THE CLEVELAND ELECTRIC ILLUMINATING COMPANY

PY-CEI/NRR-0010 L

Perry Nuclear Power Plant
Bracket Nos. 50-440; 50-441
SER Outstanding Issue No. 9
Pool Dynamic Loads

APPENDIX 3B
CONTAINMENT LOADS

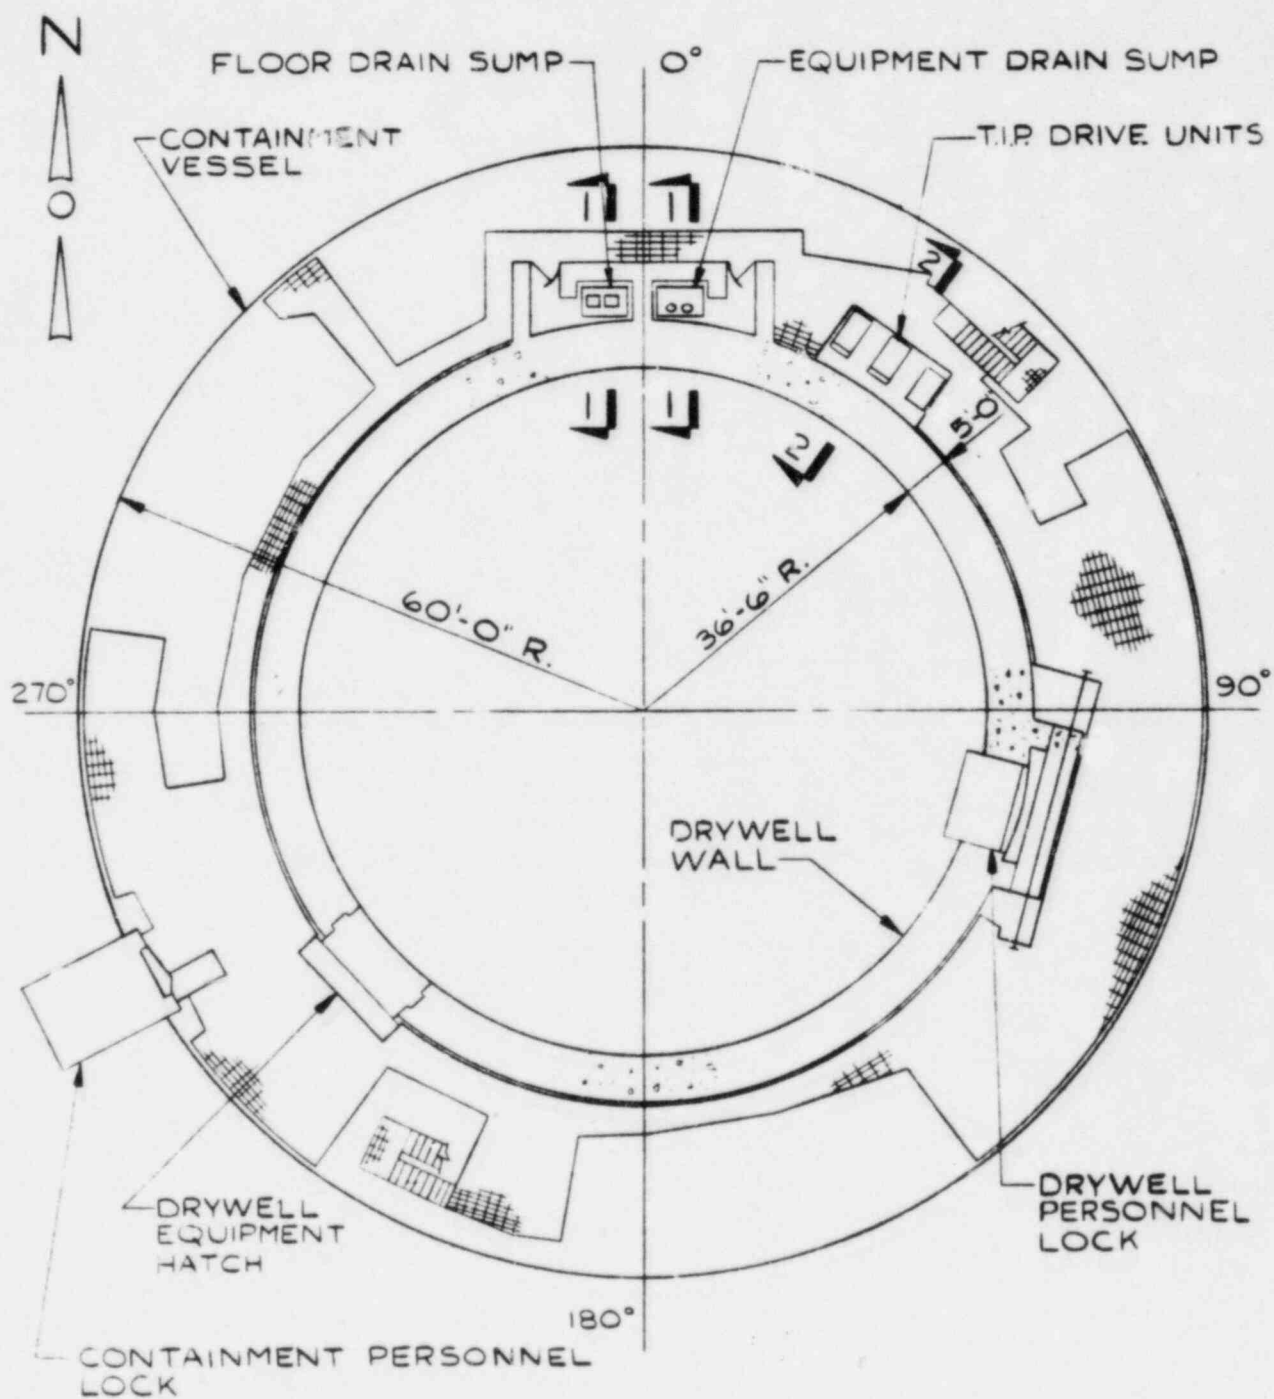
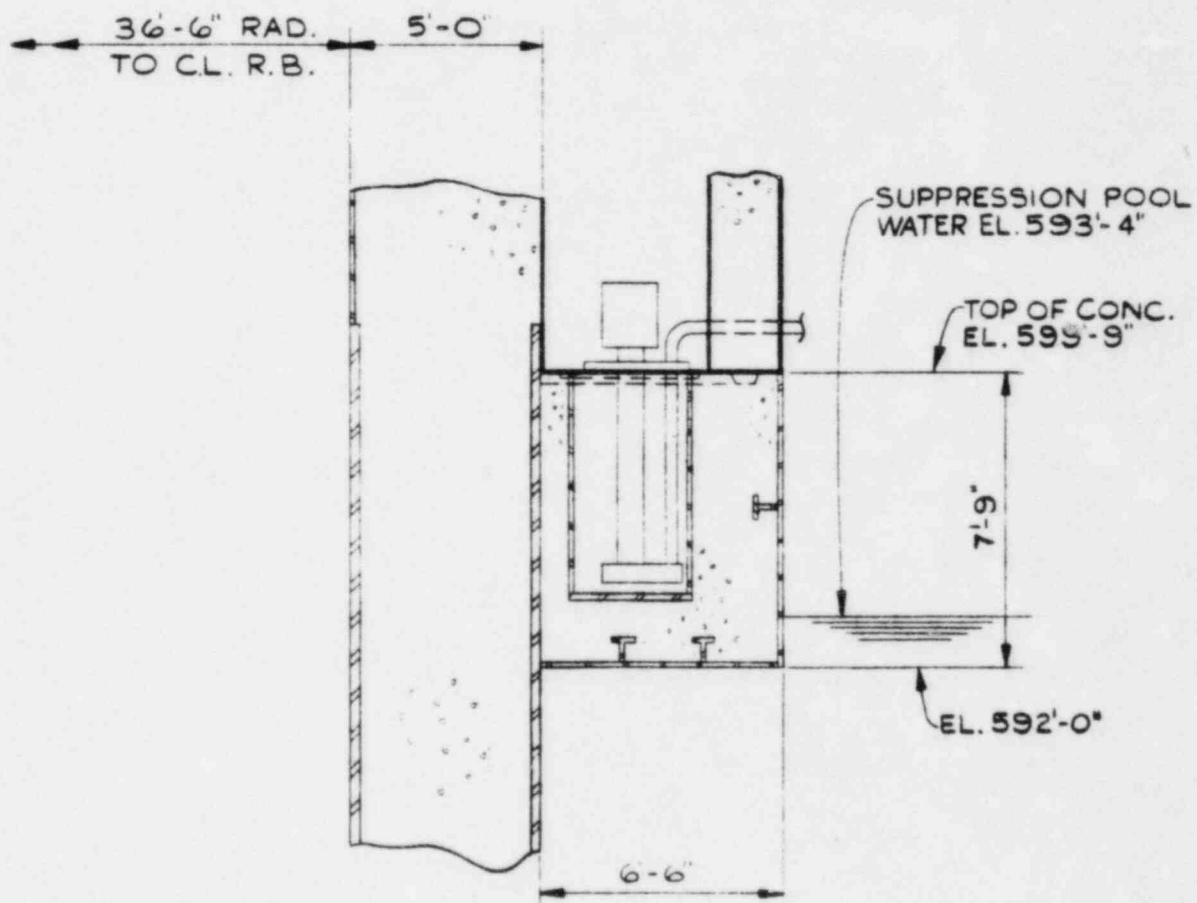
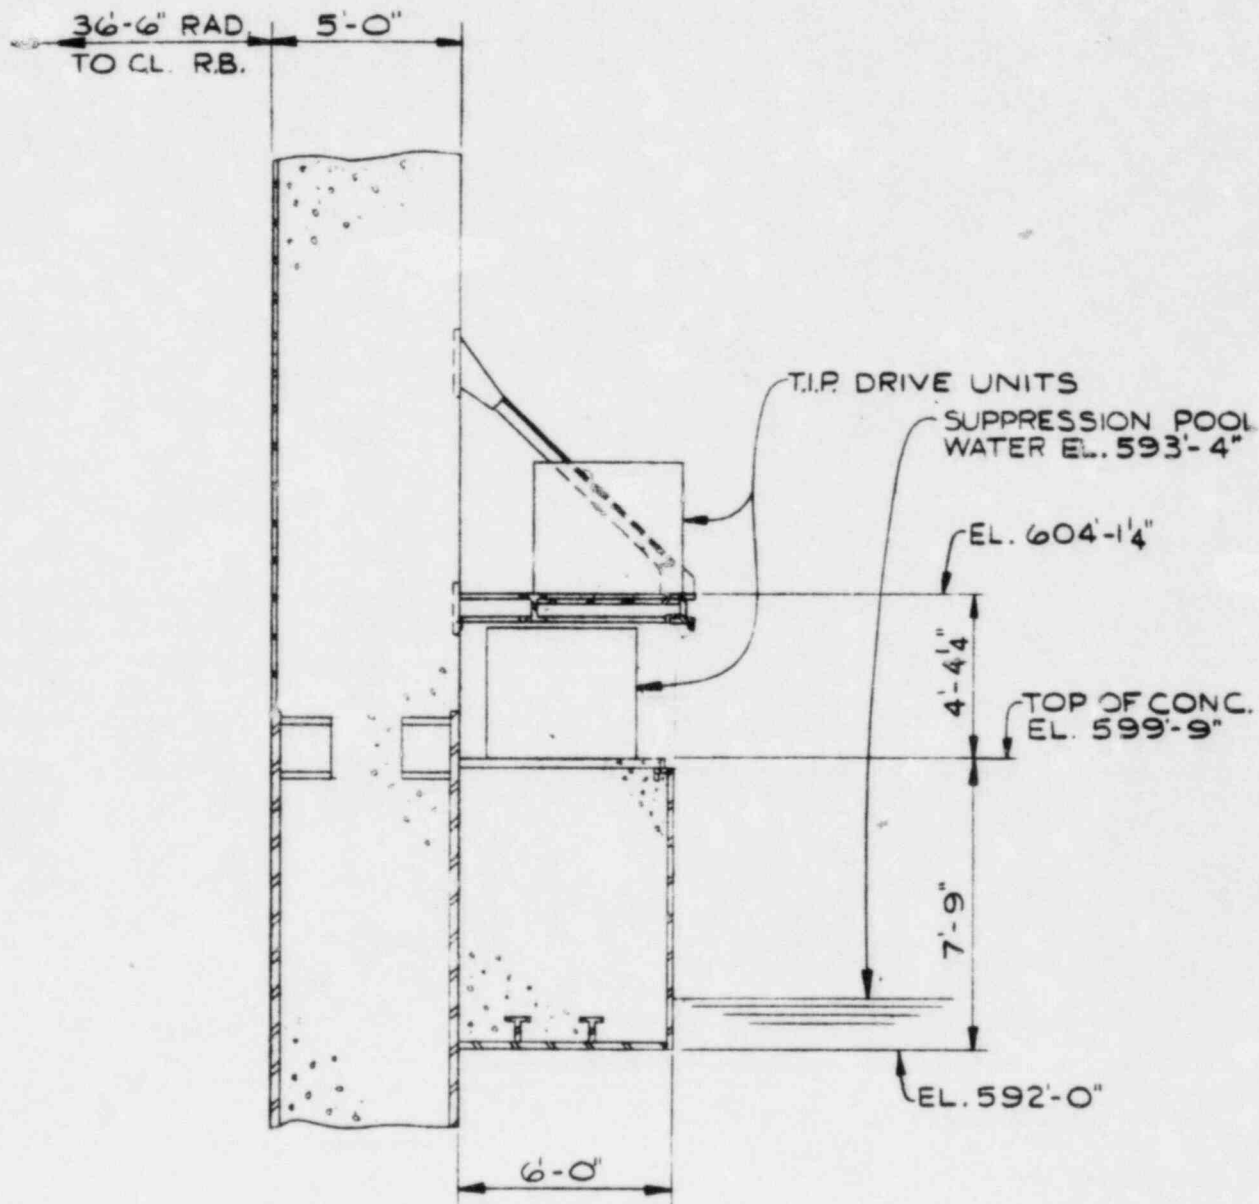
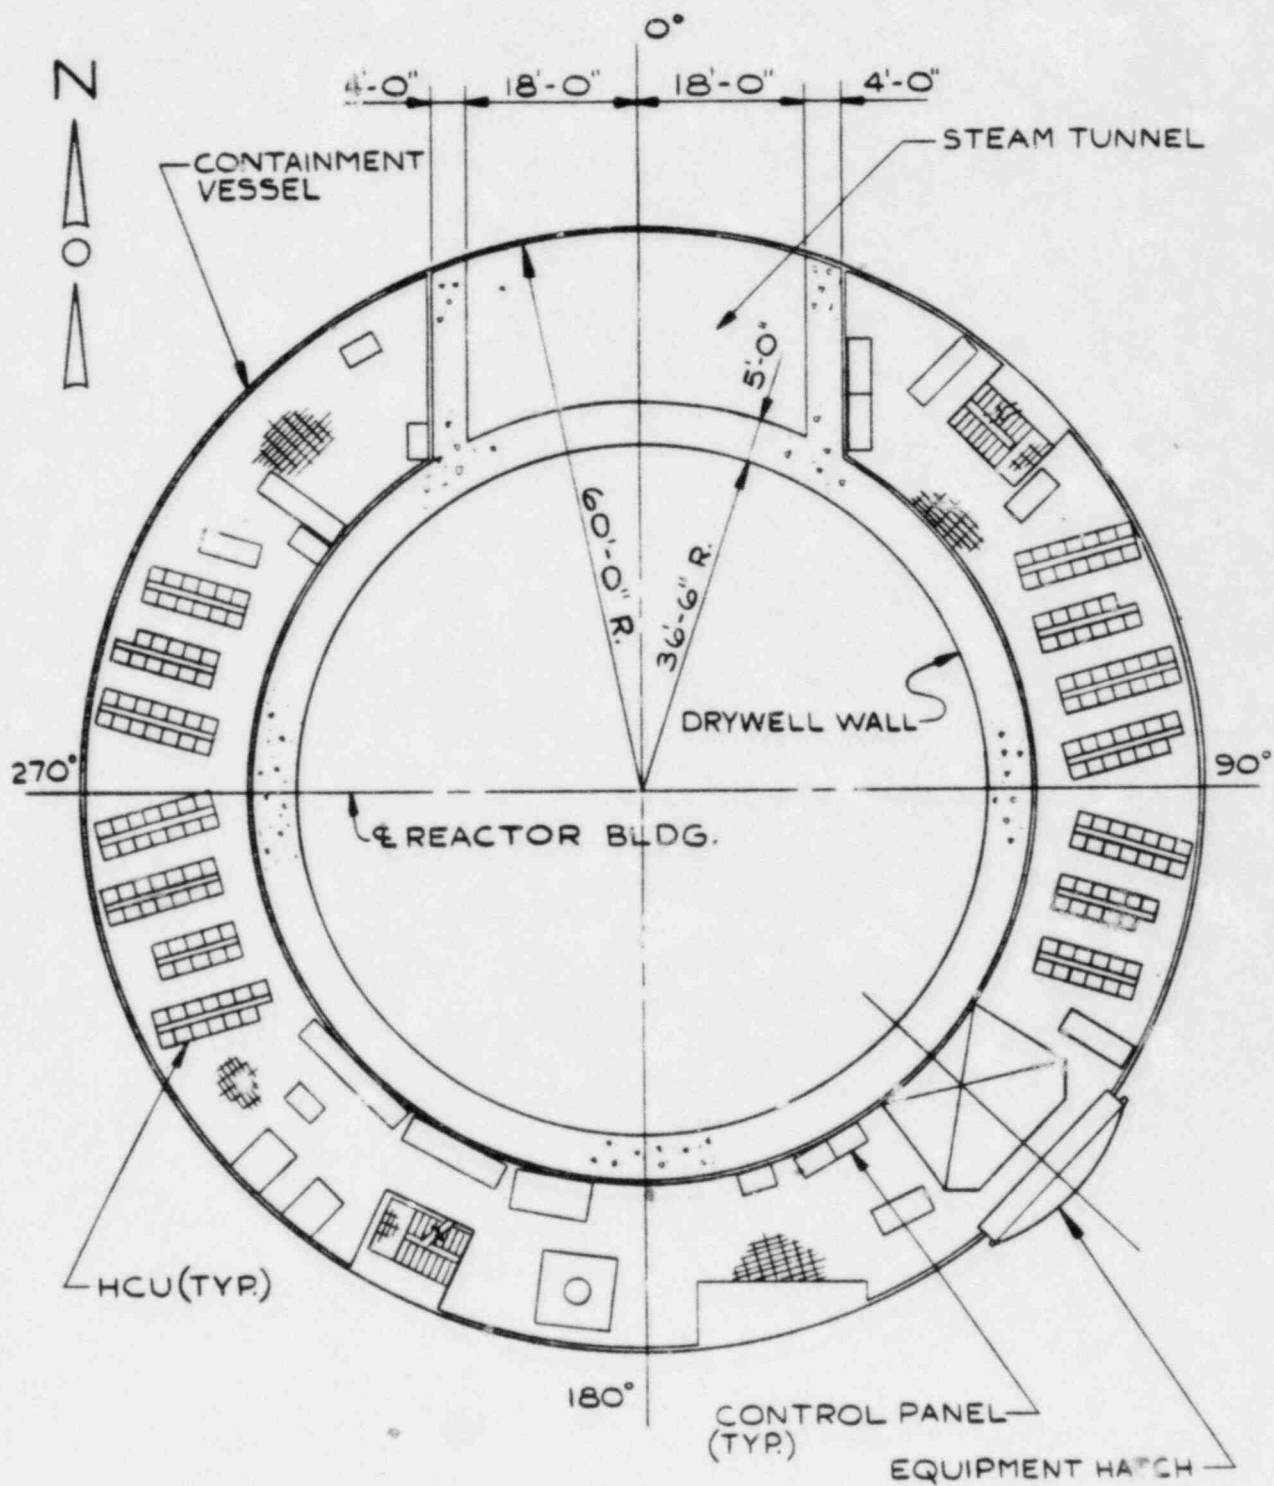
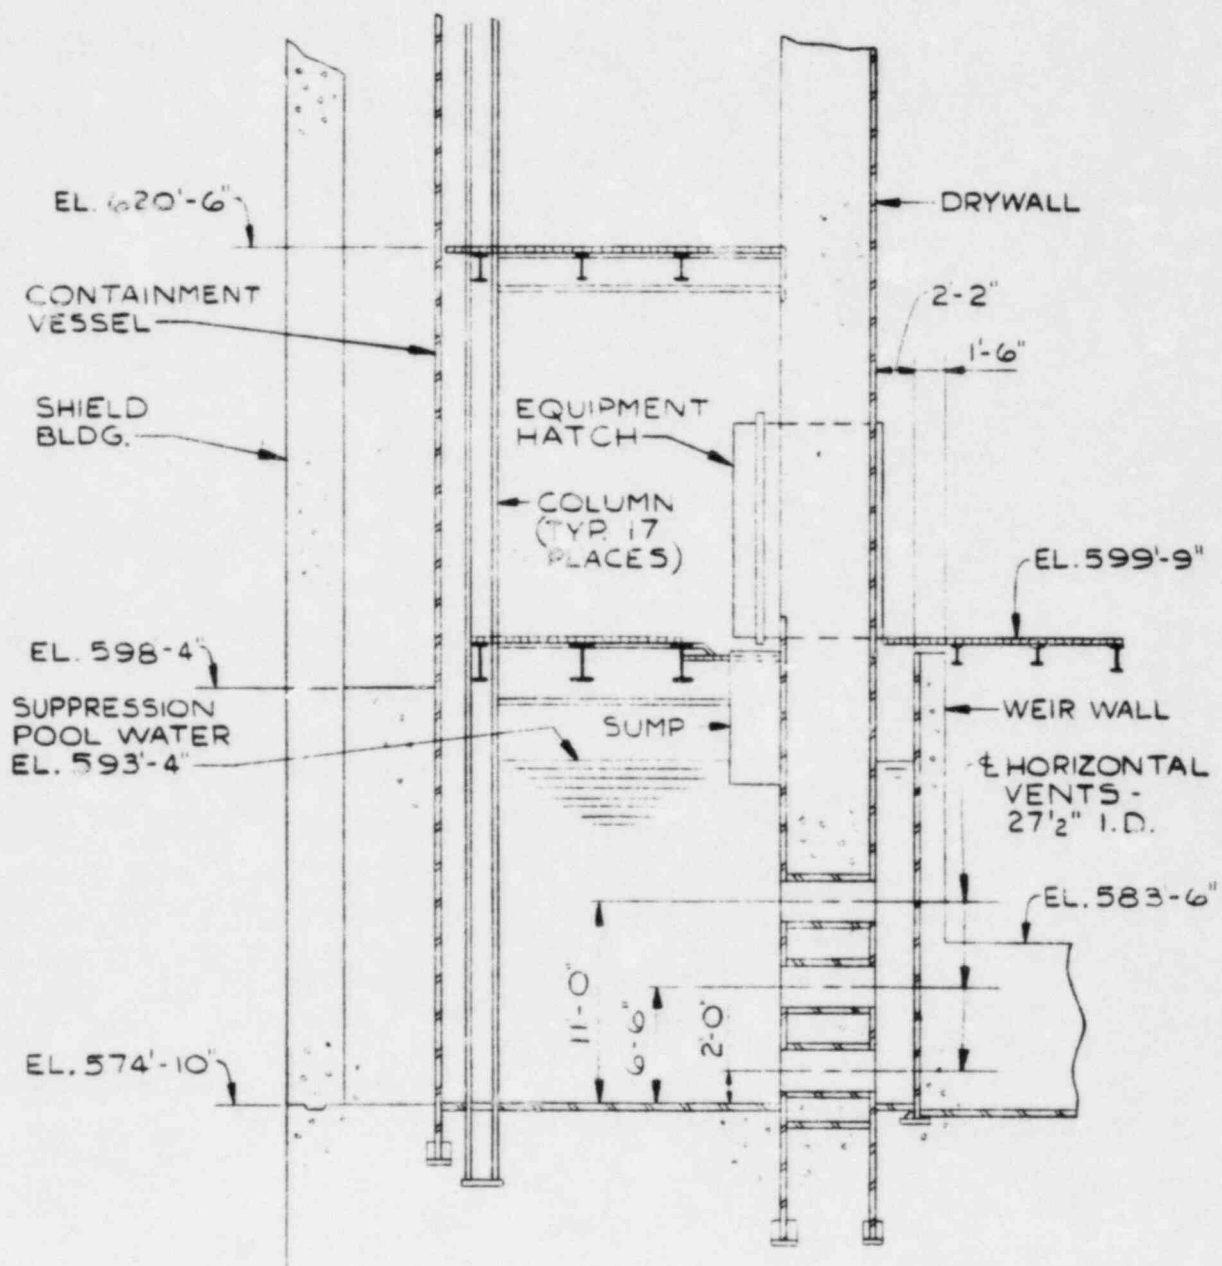
CESSAR Figures 3B-2 through 3B-6 are not applicable to Perry. See FSAR Figures 3B-1 through 3B-5.

CESSAR Figures 3B-2 through 3B-6 are not applicable to Perry. See FSAR Figures 3B-1 through 3B-5.

FIGURE 3B-6

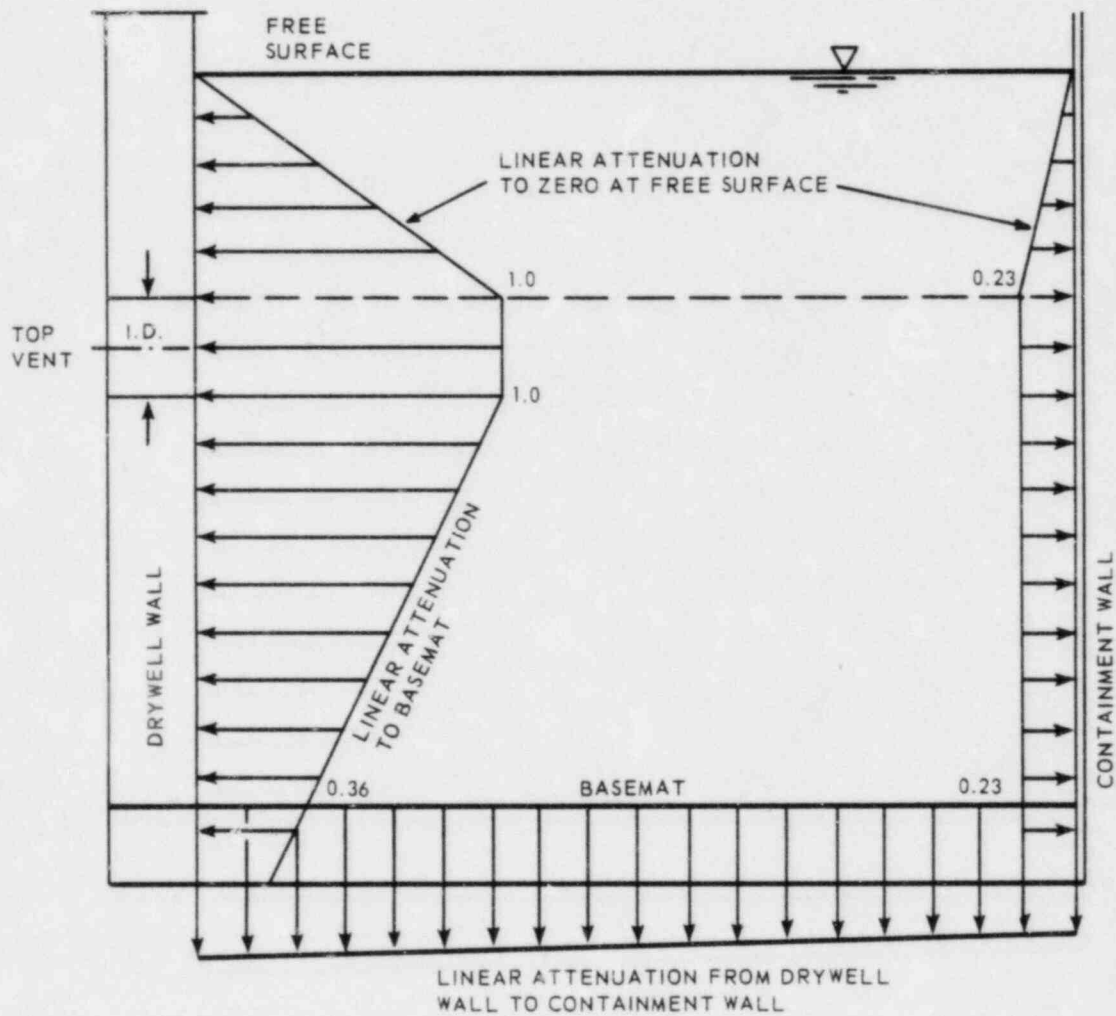
CESSAR Figure 3B-17 is not applicable to Perry. See FSAR Figure 3B-6 for the distribution of condensation oscillation loads on the drywell.

CESSAR Figure 3B-17 is not applicable to Perry. See FSAR Figure 3B-6 for condensation oscillation loads on containment.
